### LIMITING CONDITIONS FOR OPERATION AND SURVEILLANCE REQUIREMENTS

### 3/4.2.6 POWER/FLOW INSTABILITY

#### 3/4.2.7 STABILITY MONITORING - TWO LOOP OPERATION

Operating Region Limits of Specification 3.2.6  
Figure 3.2.6-1

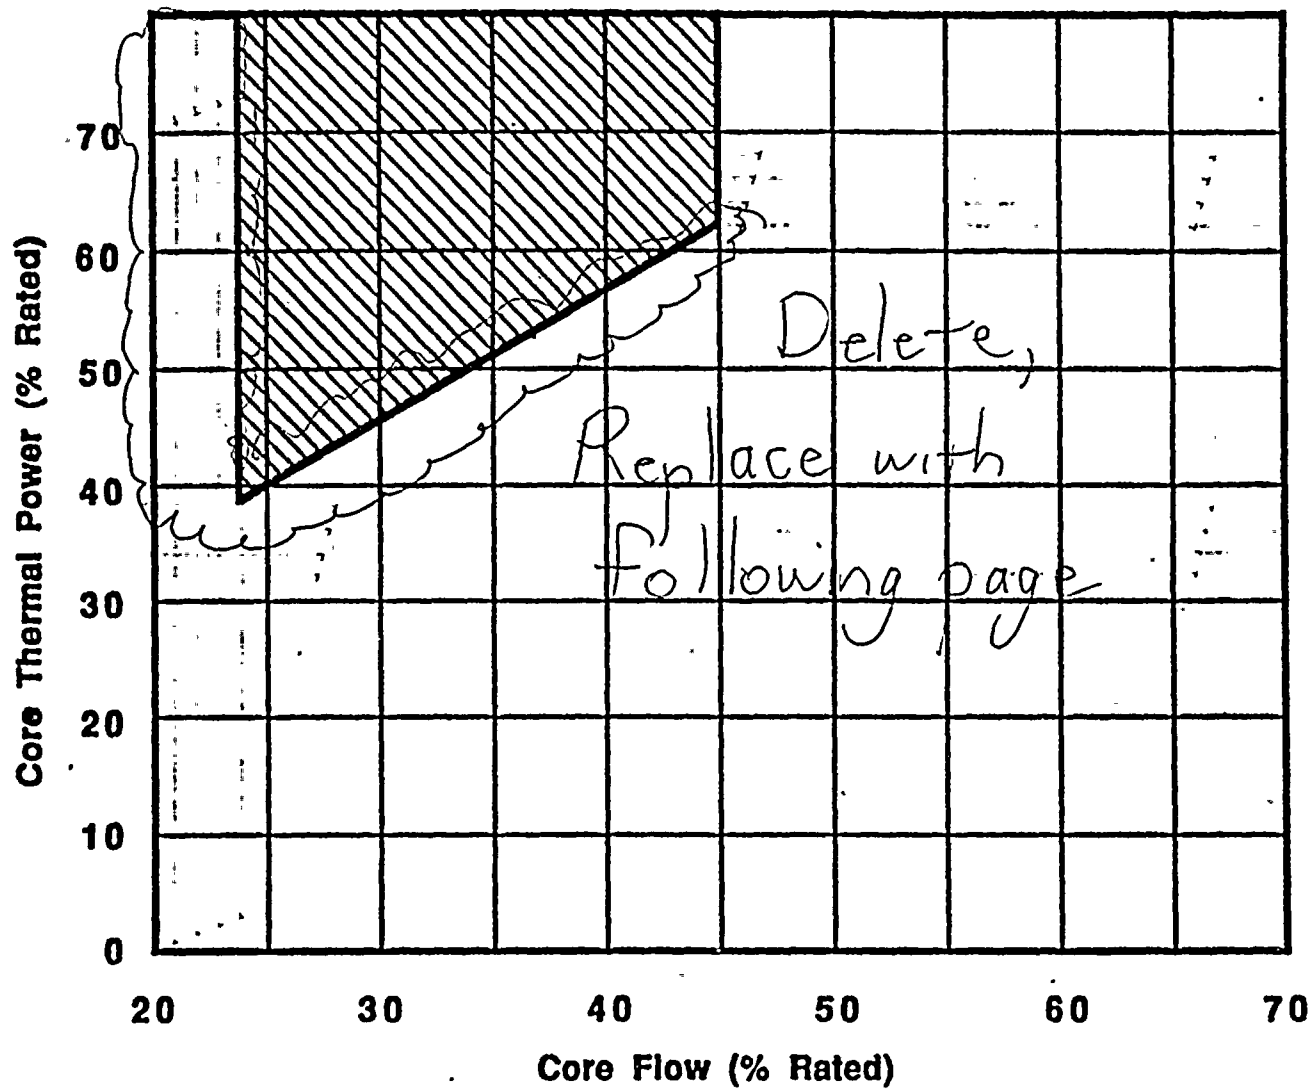
3.2.6 Operation with THERMAL POWER/core flow conditions which lay in the *Region A* crosshatched-region of Figure 3.2.6-1 is prohibited.

*IMMEDIATELY*

With THERMAL *Region A* POWER/core flow conditions which lay in the crosshatched-region of Figure 3.2.6-1, initiate corrective action within 15 minutes to establish a THERMAL POWER/core flow condition which lays outside the crosshatched-region within 2 hours.  $\alpha$  MANUAL SCRAM.

*Region A* 4.2.6 The THERMAL POWER/core flow conditions shall be verified to lay outside the crosshatched-region of Figure 3.2.6-1 once per 24 hours  $\times$  when operating in the region of *APPLICABILITY*.

Operating Region Limits of Specification 3.2.7  
Figure 3.2.7-1

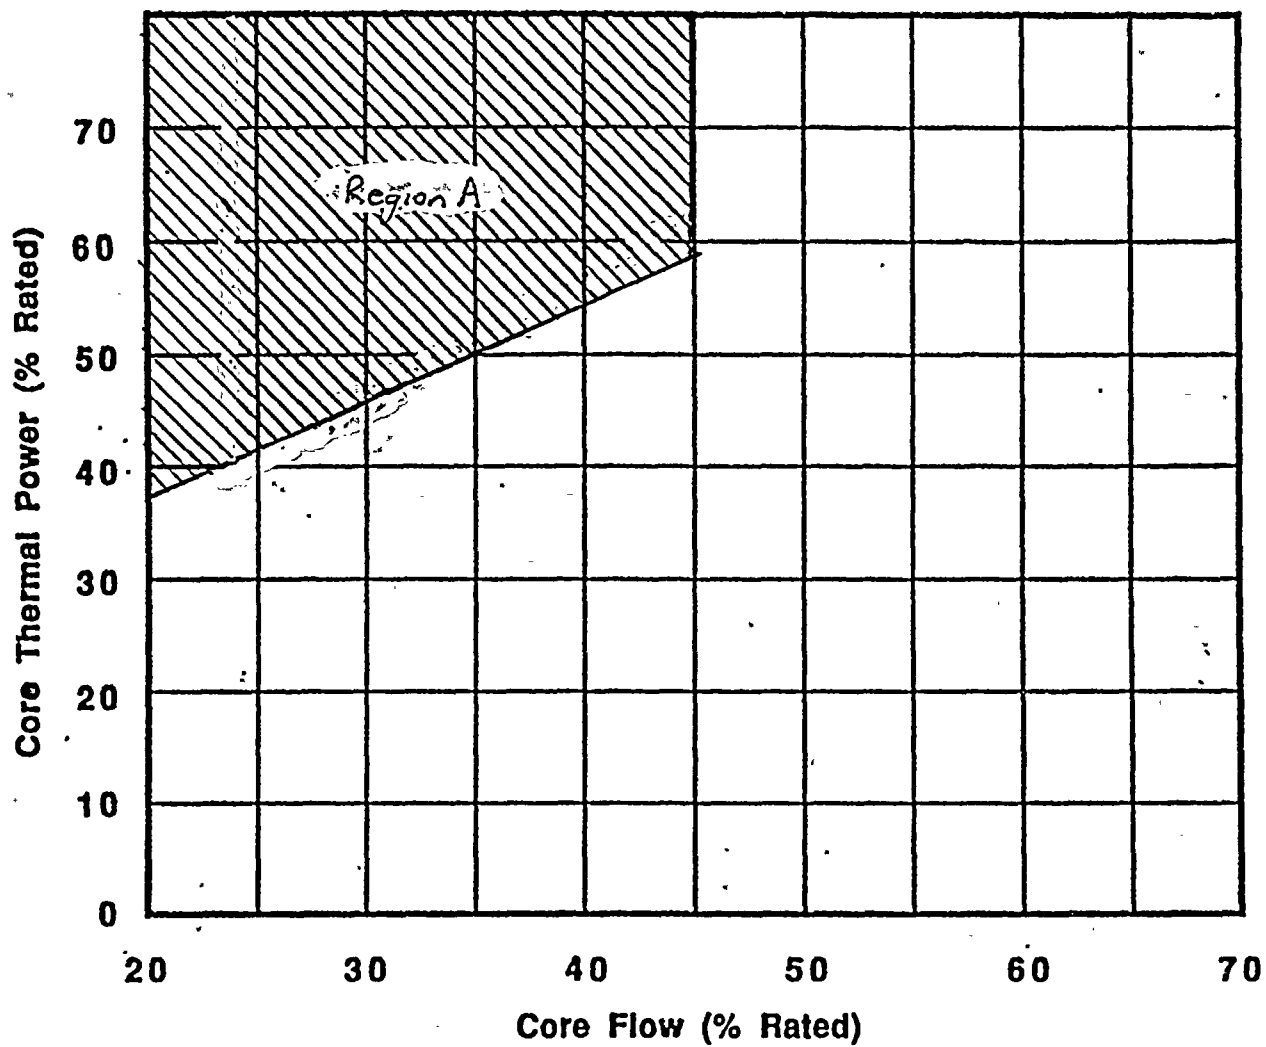
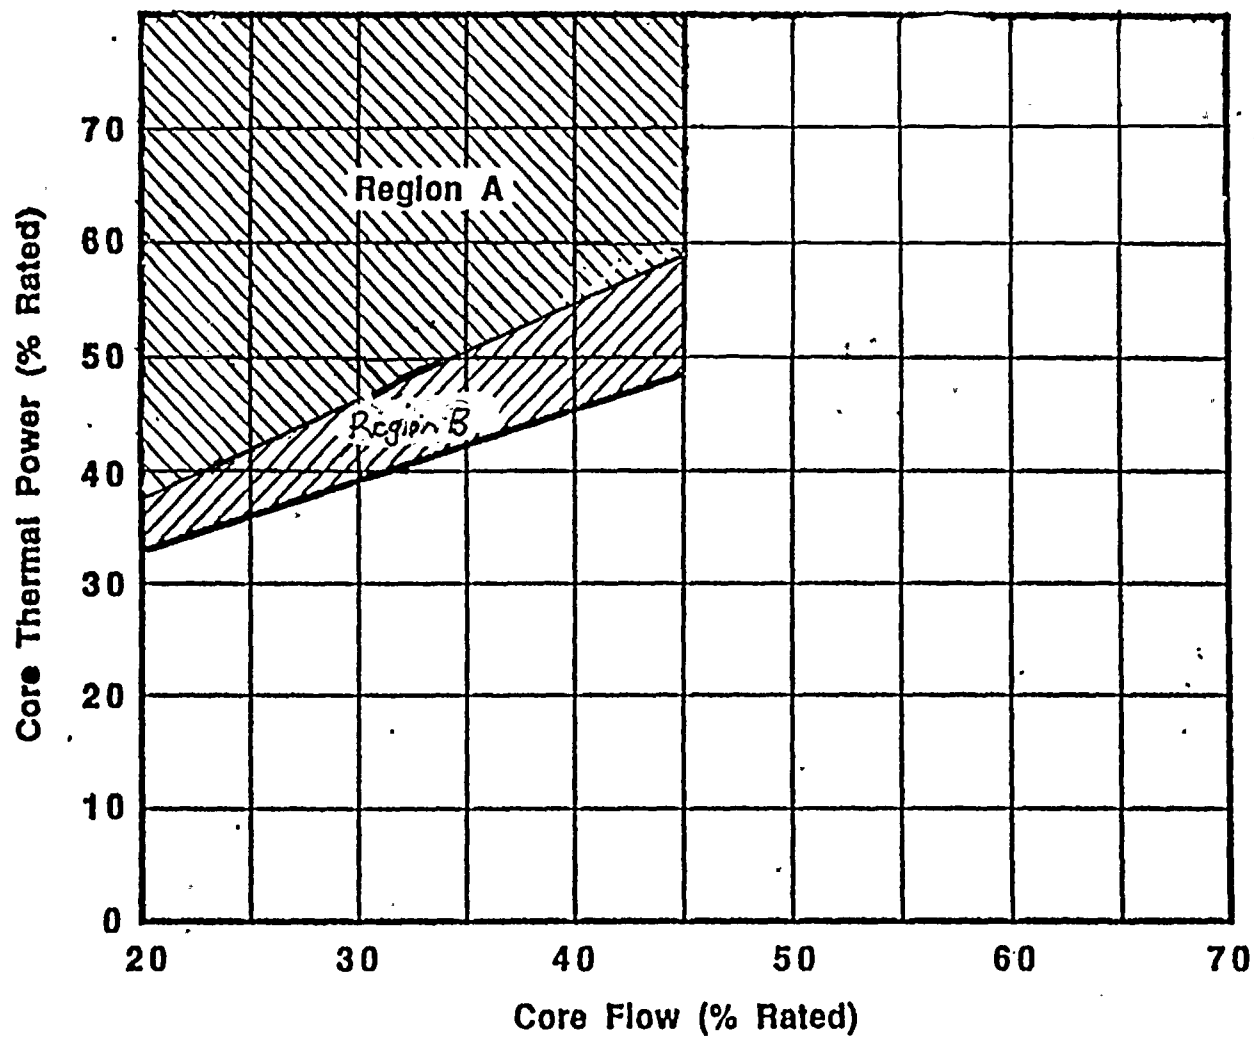
APPLICABILITY: OPERATIONAL CONDITION 1 with THERMAL POWER/core flow in Region B of Figure 3.2.7-1, with two reactor coolant system recirculation loops in operation and total core flow less than 45% of rated total core flow, or with one reactor coolant system recirculation loop not in operation.

Within 2 hours exit the region of APPLICABILITY. Establish baseline APRM and LPRM neutron flux noise levels prior to re-entering Region B of Figure 3.2.7-1.

- 3.2.7 The stability monitoring system shall be operable\* and the decay ratio of the neutron signals shall be less than .75 when operating in the region of APPLICABILITY.

APPLICABILITY: OPERATIONAL CONDITION 1, with two recirculation loops in operation and THERMAL POWER/core flow conditions which lay in Region B of Figure 3.2.7-1

Operating Region Limits of Specification 3.2.7<sup>8</sup>  
Figure 3.2.7-1<sup>8</sup>

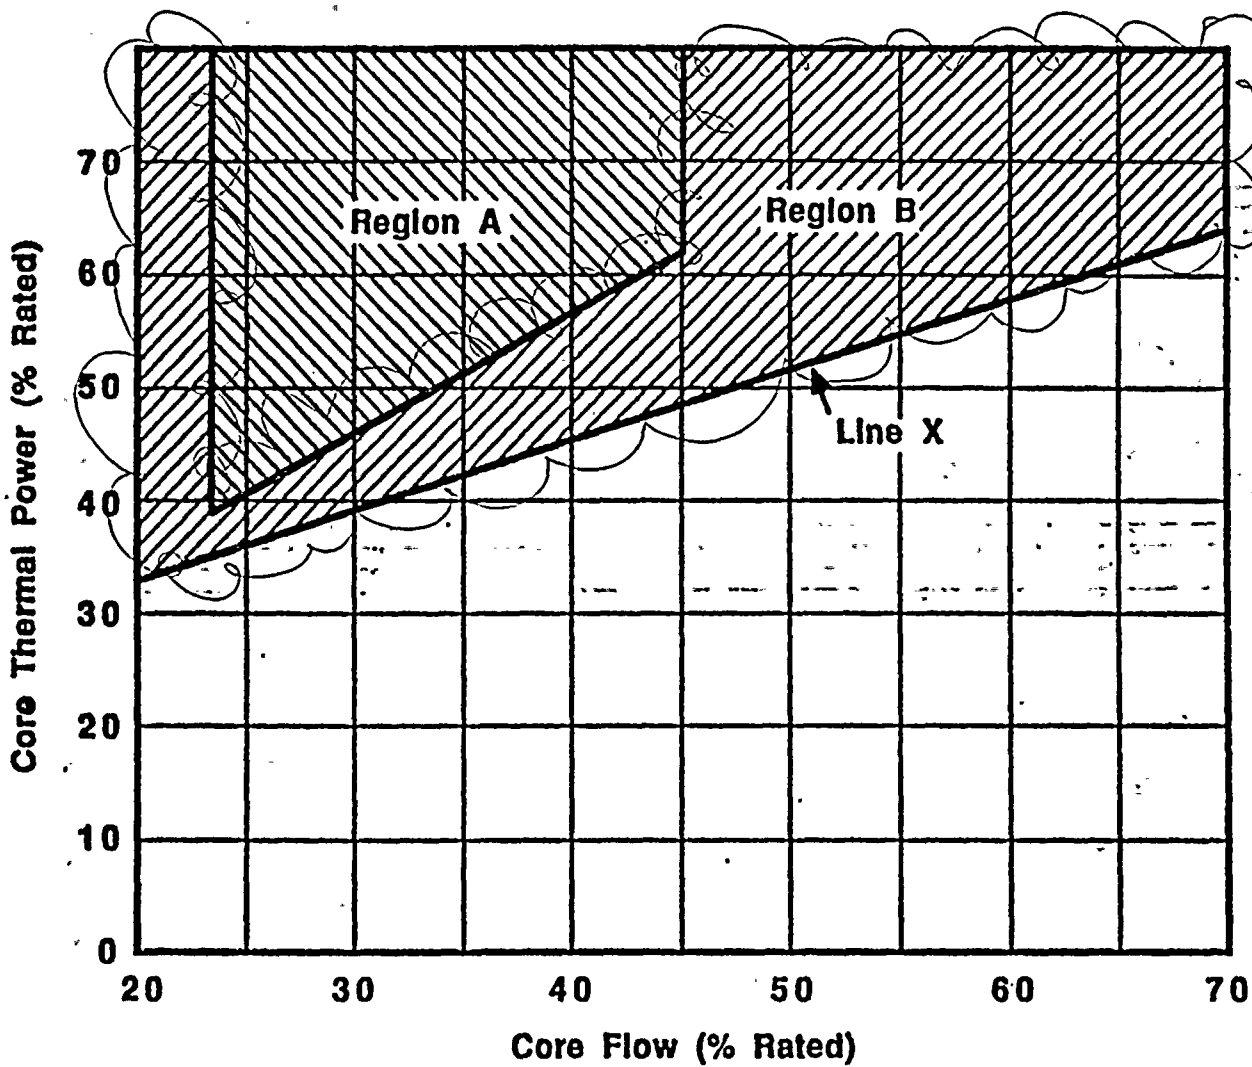
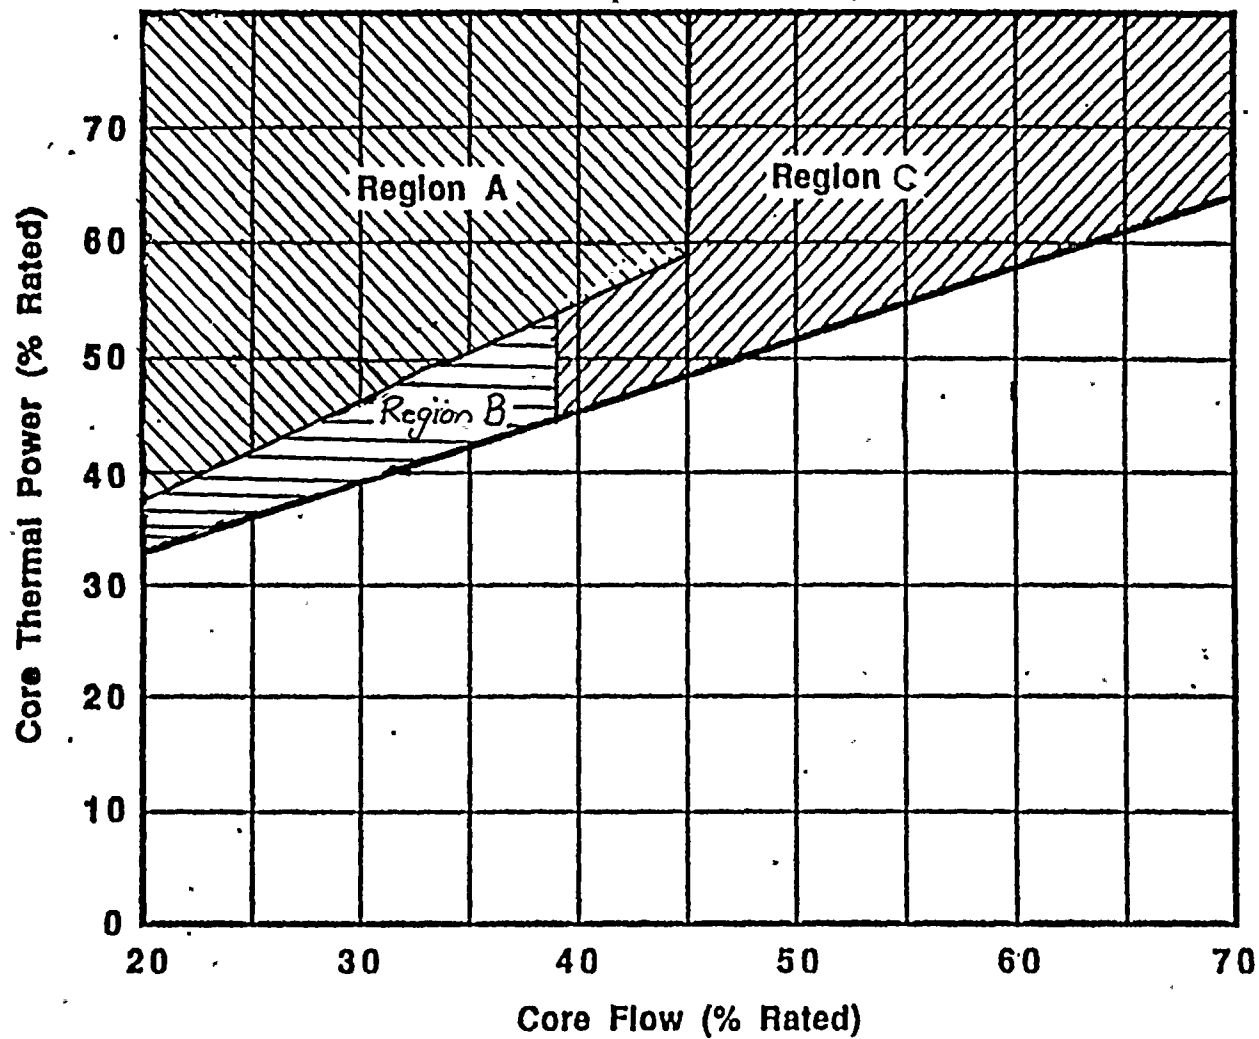
APPLICABILITY: OPERATIONAL CONDITION 1, with one recirculation loop in operation and THERMAL POWER/core flow conditions lay in Region C of Figure 3.2.8-1.

Delete, Replace with following page

Operating Region Limits of Specification 3.4.1.1  
Figure 3.4.1.1-1

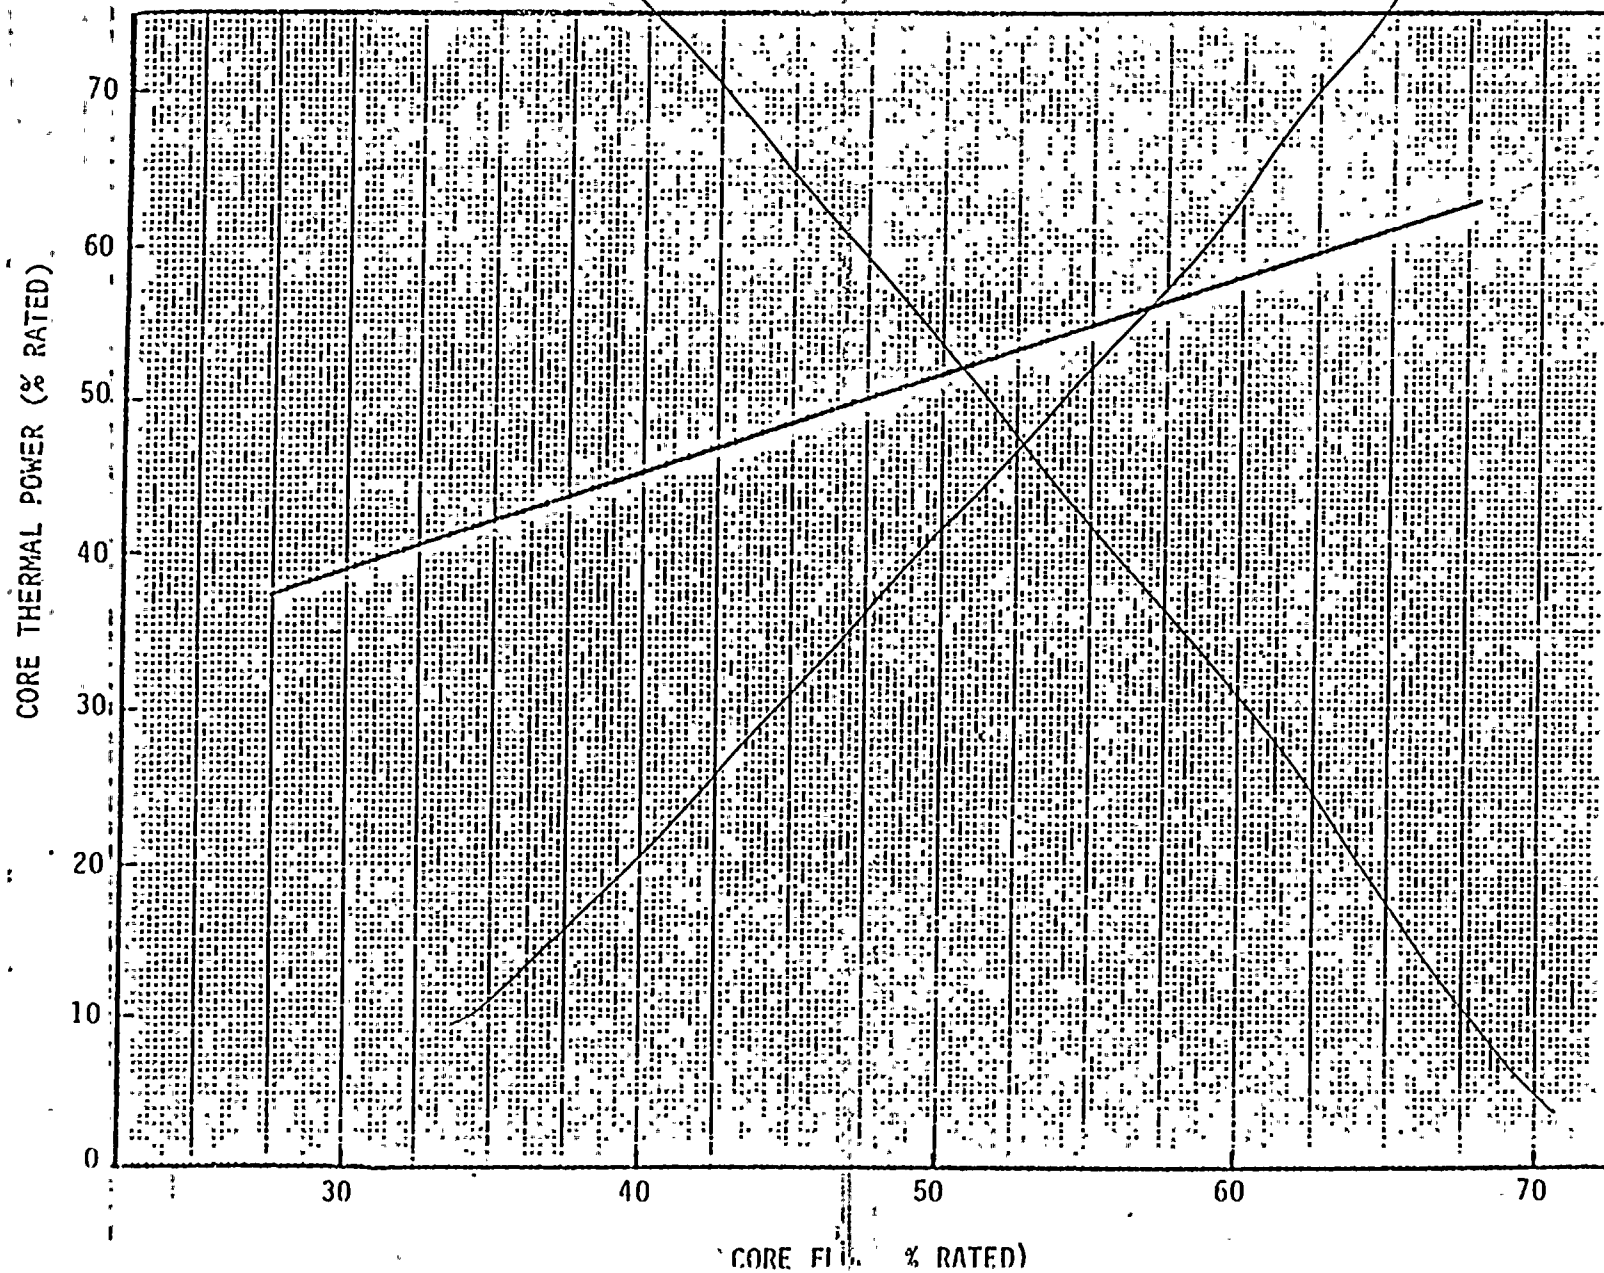
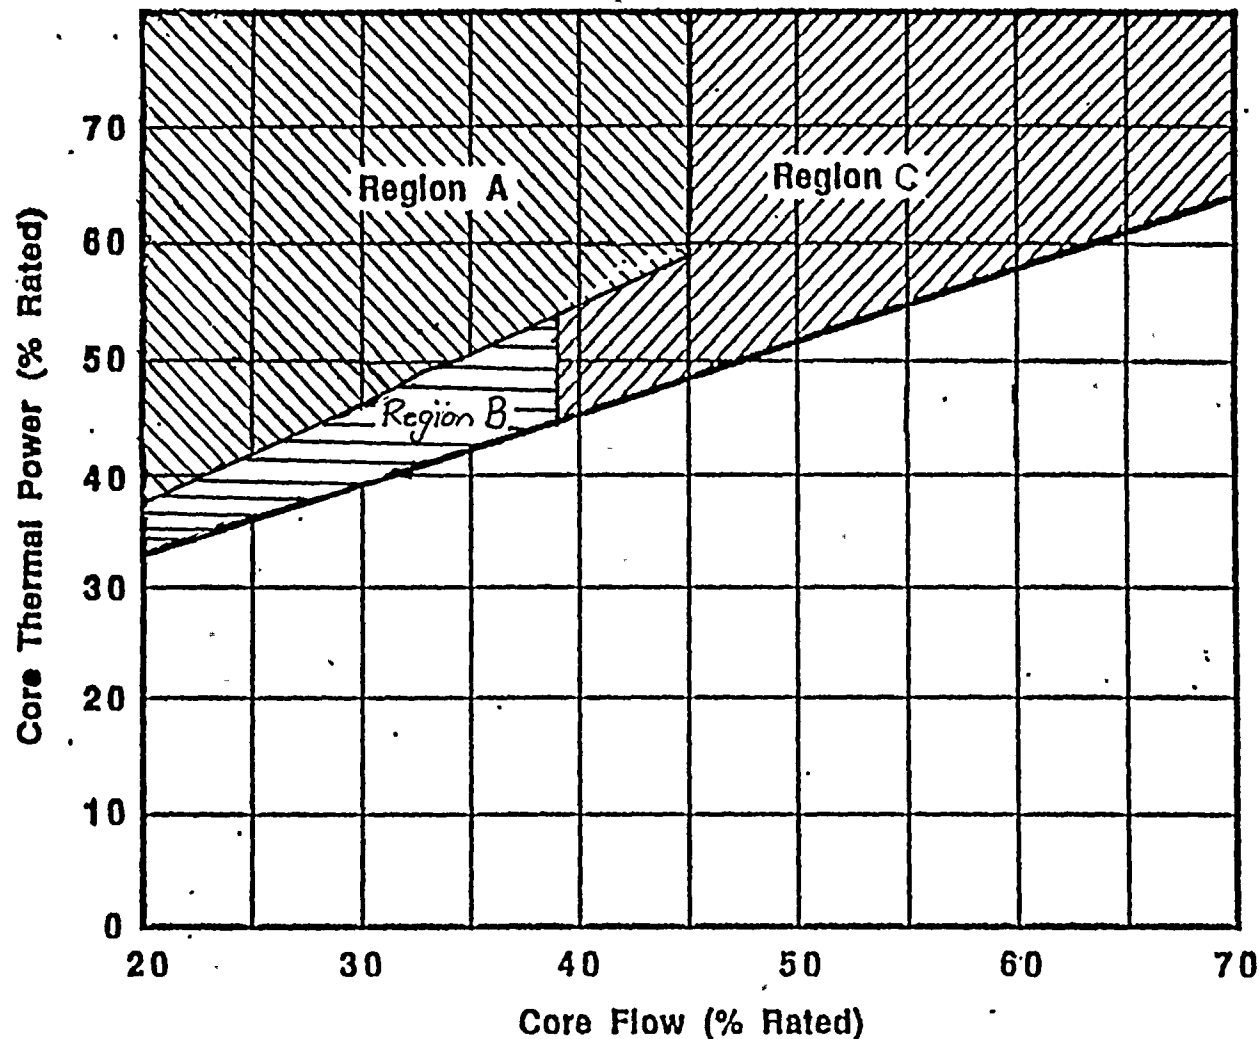
- a. ~~Verify that core flow is greater than or equal to 39% of rated core flow or that THERMAL POWER/core flow conditions lay below the line in Figure 3.4.1.1-1. With core flow less than 39% of rated core flow and THERMAL POWER/core flow conditions above the line in Figure 3.4.1.1-1, initiate action to reduce THERMAL POWER to below the line in Figure 3.4.1.1-1 or increase core flow to greater than or equal to 39% of rated core flow within the next 4 hours.~~

- LCO 3.2.6 and 3.2.8*  
b. Verify that the requirements of LCO 3.2.<sup>8</sup> are met, or comply with the associated ACTION statement(s) within the specified time limits.

Delete,  
Replace w/ following page

2. Verify that THERMAL POWER/core flow conditions lay outside Region B of Figure 3.4.1.1-1.

With THERMAL POWER/core flow conditions which lay in Region B of Figure 3.4.1.1-1, IMMEDIATELY initiate action to exit Region B by either decreasing THERMAL POWER with control rod insertion or increasing core flow with flow control valve manipulation. Within 1 hour exit Region B. The starting or shifting of a recirculation pump for the purpose of exiting Region B is specifically prohibited.
